8495A-02

Modification Recommended Service Note

8495A – Manual Step Attenuator

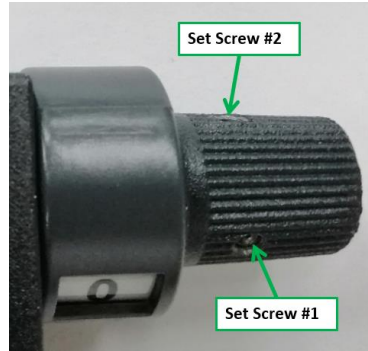
The identified batch of step attenuator's rotating knob may become loose when the user applies an extended force to turn the knob beyond the maximum attenuation value. This will cause the attenuation value to be located outside of the indicator window and may create confusion on the actual attenuation value.

The attenuation knob was not securely tightened to the internal shaft, causing it to turn further. This is due to an insufficient torque that was applied to tighten the set screw during assembly at the factory.

This issue can be fixed by re-tightening the screws on the rotating knob.

- (1) Rotate the knob clockwise until it reaches the last attenuation step, which is at 0 dB.
- (2) Loosen the 2 set screws (0.05" Hex screw bit) on the knob slightly until the knob can freely move, and then align the knob so that the indicator label number "0" is located at center on dial cover window.

- (3) Tighten both set screws with a 0.05" Hex screw bit and 4.0in-lbs torque driver.

(4) After tightening both set screws, rotate knob counter-clockwise until it reaches the maximum attenuation (11/70/110dB). To ensure the attenuator functions properly, rotate the knob clockwise back to minimum attenuation (0dB), and repeat the movement for 10 cycles.
